Specification Mintech./CV2362 - CV2368
 Issue 2A, Dated September 1967
 To be read in conjunction with K1001
 ignoring clauses:- 5.2, 5.3, 5.8.

SPECIFICATION Mintech./CV2362-CV2368, ISSUE 2A, DATED SEPTEMBER 1967.

AMENDMENT No.1

ELECTRONIC VALVE SPECIFICATIONS
SPECIFICATION MINTECH/CV2362 - CV2368,
ISSUE 2A, DATED SEPTEMBER 1969
AMENDMENT NO 2

Page 5. Outline Drawing.

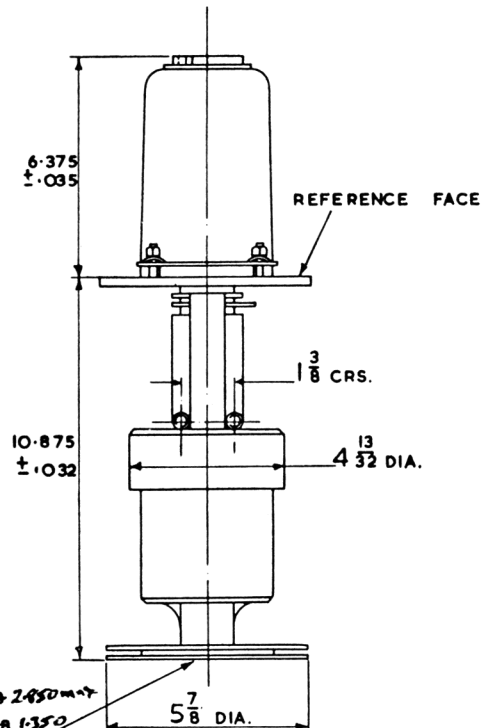
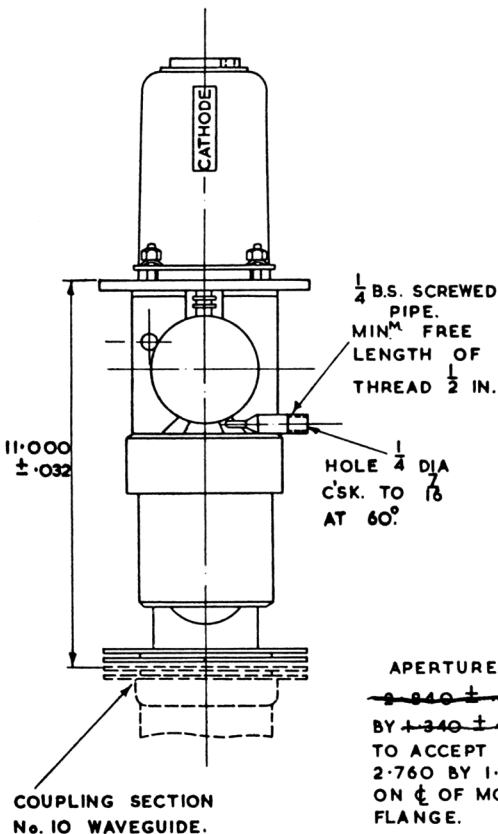
View in top right hand corner.

The flange diameter is shown as "6.000 Dia + .000"
- .000
which should be amended to read "6.000 Dia + .000"
- .010.

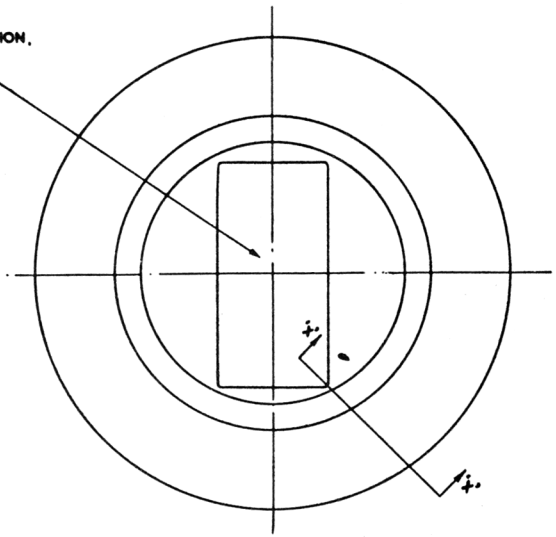
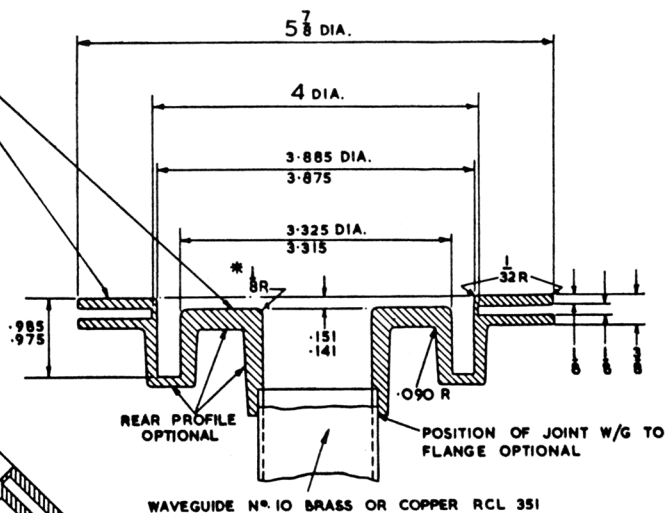
PAGE 1 Text, headed 'Aperture' (bottom centre of page)

Delete the first two lines of the text " $2.840 \pm .008$ by $1.340 \pm .008$ " and insert " 2.850 max by 1.350 max"
